**SRI SHIRDI SAI BABA TEMPLE
ADDENDUM No. 1
12 December 2008**

This Addendum forms a part of Contract and clarifies, corrects or modifies original Bid Documents.

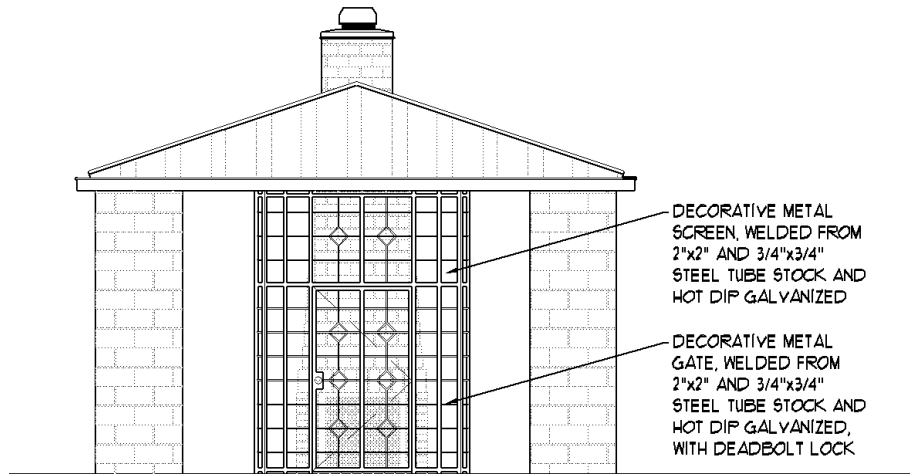
1. *Sheet A101 room finish schedule is incomplete.* The room finish schedule for the project is included above.
2. *Sheet A100 Dhuni screen for the fireplace is not detailed.* The following detail illustrates the screen for the Dhuni. The screen for the shrine is similar.

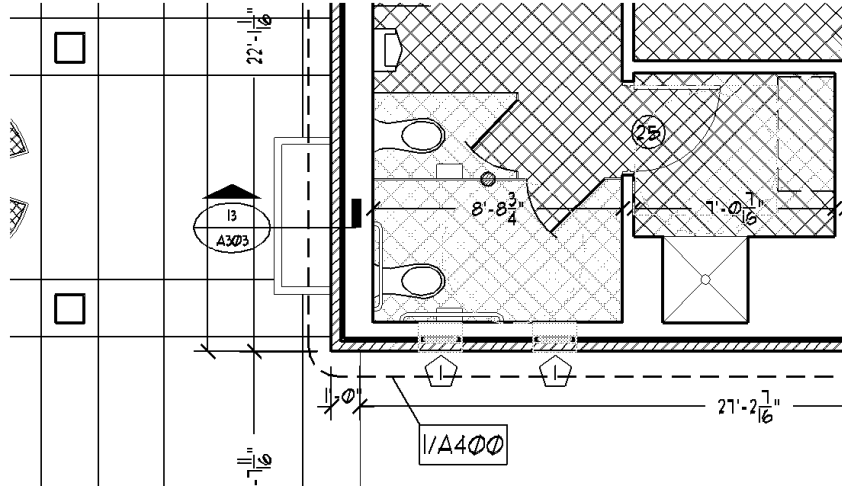
3. *There are numerous dimensions and material notations missing from the set.* The bid documents, as clarified by this addendum, should be sufficient for pricing the project. The final construction drawings (the approved building permit drawings), include additional notes and dimensions.
4. *The Footbath Detail 13/A303 is not noted anywhere else on the plans.* The attached detail from 1/A100 locates the footwash. This detail also identifies the windows in the toilet rooms as type "I".

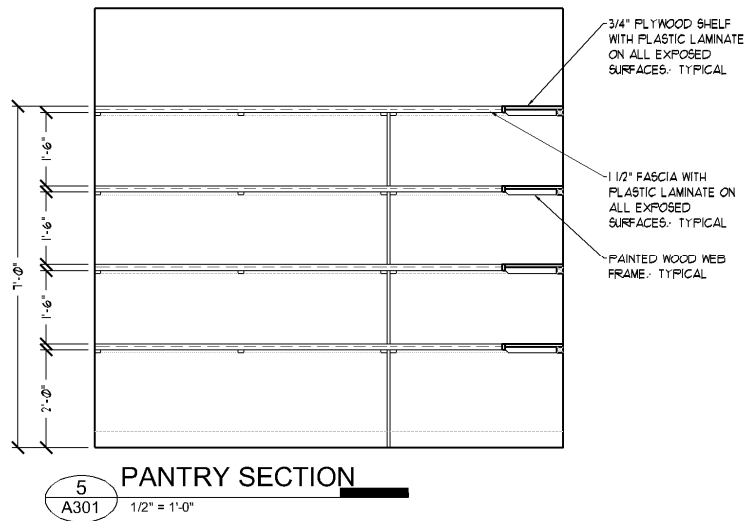
5. *What type of roof sheathing and vapor barrier is to be installed? All of the metal roofs consist of structural panels mechanically fastened to purlins. There is no sheathing and no vapor barrier associated with this system.*
6. *Room D102/Pantry shows shelves on the plan. Spec? Quantity? The following detail clarifies the pantry shelving.*

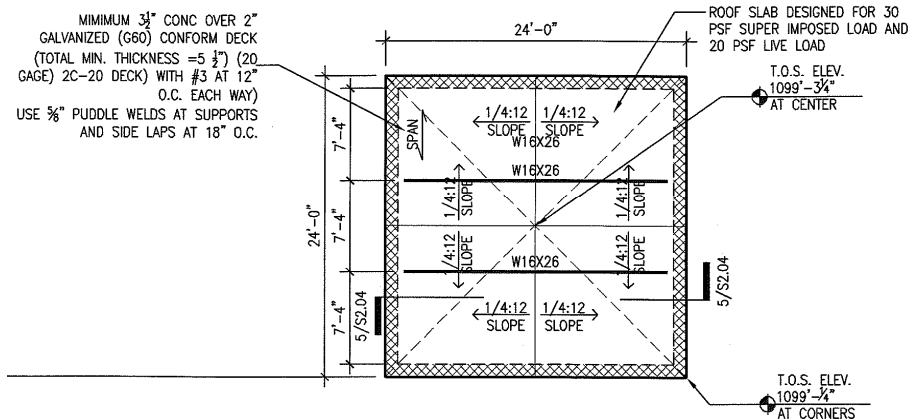
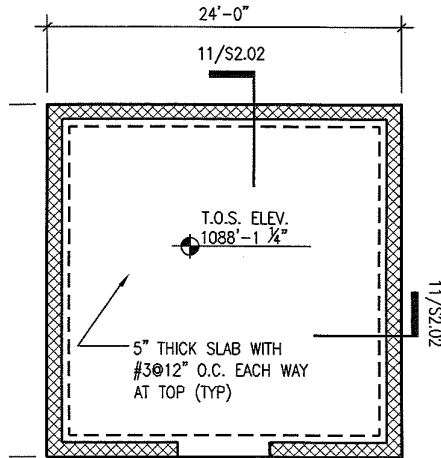
7. *Minimal information is provided on the Gopuram, the (4) ornamental elements around the Gopuram, and the Dome: Is this a proprietary supplier? By owner? How are these attached, flashed, and*

waterproofed to the roof below? For pricing purposes, include in the base bid the provision of a gopuram and corner pavilions in accordance with the proposal below (including Alternate A) from INDesign. Their proposal includes the design of the mounting details for the gopuram.

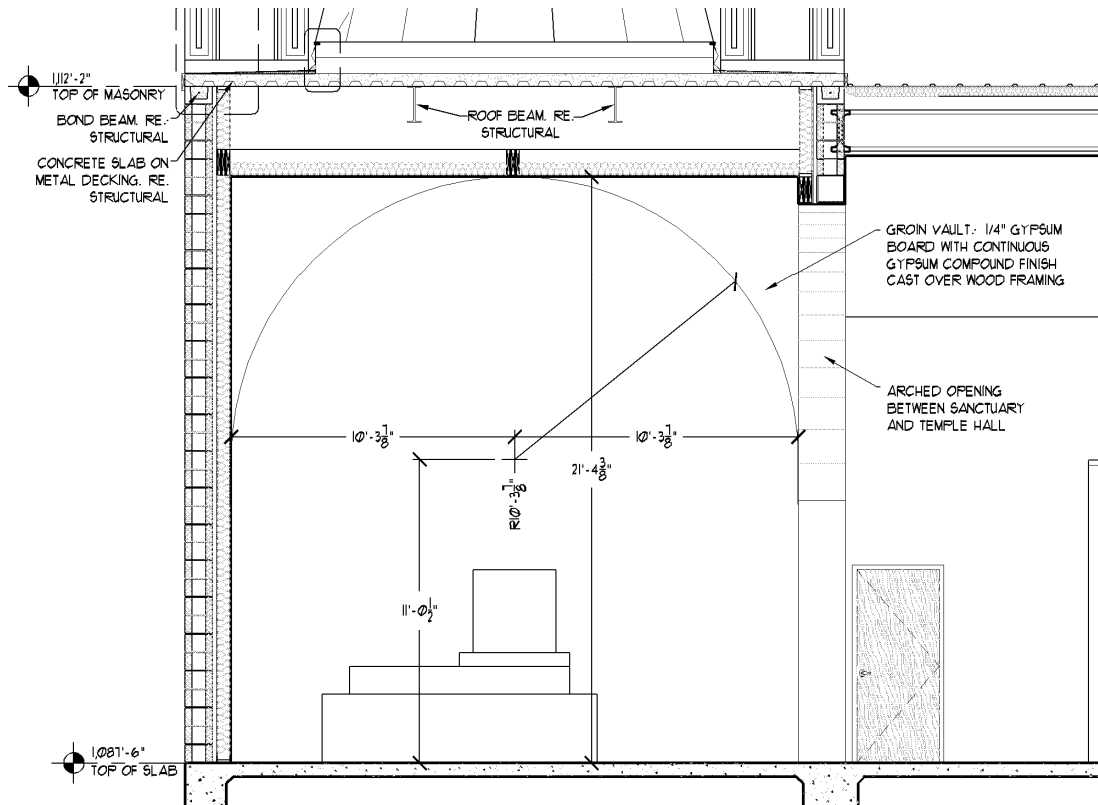
17. The groin vault shown in the Sanctuary shows to be open on the Temple side according to Section 1/A301. This conflicts with Section 2/A300. Please clarify. There is an arched opening between the temple hall and the sanctuary. This is correctly shown on Sheets A301 and A300. The following detail clarifies this condition (note the revision of certain dimensions relative to the bid set, and the amendment of the note concerning the gypsum sheathing of the vaulted ceiling).

GREEN ROOF PLAN (MEDITATION ROOM)

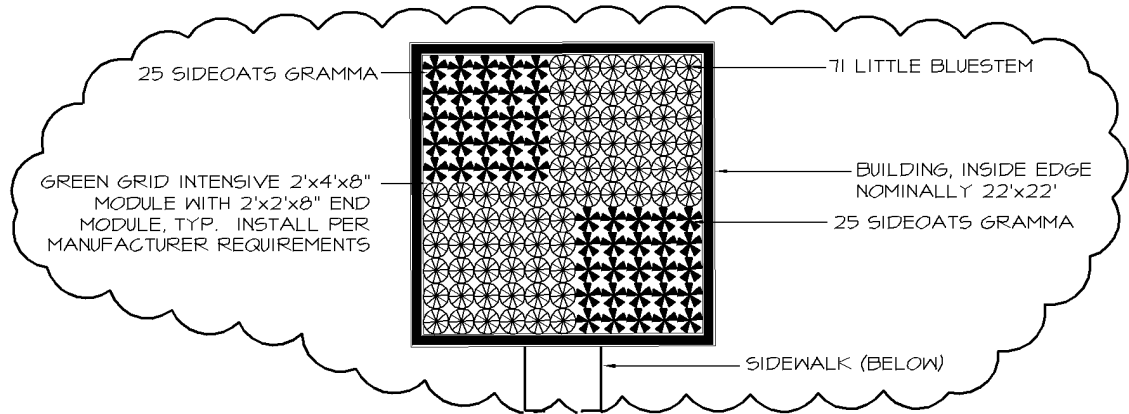
21. *Detail 10/A302 states "Re. Manufacturer Spec. for Growing Medium, Vegetation, and Waterproofing Barriers". What manufacturer? This needs to be completely specified. The notation on this detail is misleading. The components of the green roof system are as follows. The actual roof is a TPO membrane over tapered insulation, per Specification 07540.*

1. Green Roof shall have the following requirements

- a. Provide green grid 2' x 4' x 8" modules with 2' x 2' x 8" end piece modules.
- b. Provide 71 Little Bluestem and 50 Sideoats Grama (24" on center, square spacing).
- c. Provide 3" mulch for all landscape areas within the green grid area
- d. Install green grid and landscaping as recommended by manufacturer.
- e. Contact for green grid:
David Dippel
Austin Office
Phone: (512) 651-7146
Fax: (512) 651-7101
David.Dippel@greengridroofs.com

2. Provide drip irrigation for green roof

- a. Inline drip tube with emitters 12" on center.
 - i. Space drip tube 12" apart and not further than 6" from inside edge of parapet (similar to Hunter drip line).
 - ii. Install drip tube below mulch
- b. Add one irrigation zone for green roof (Zone 23)
- c. Provide 150 mesh wye filter and inline pressure regulator, 40 psi max (similar to Hunter drip zone kit)
- d. Irrigation lateral (3/4") shall run on outside of building, within copper 1-1/2" irrigation sleeve
- e. Install one irrigation valve (Zone 24) to automatically drain vertical irrigation lateral to surface. Add splash block for drain.
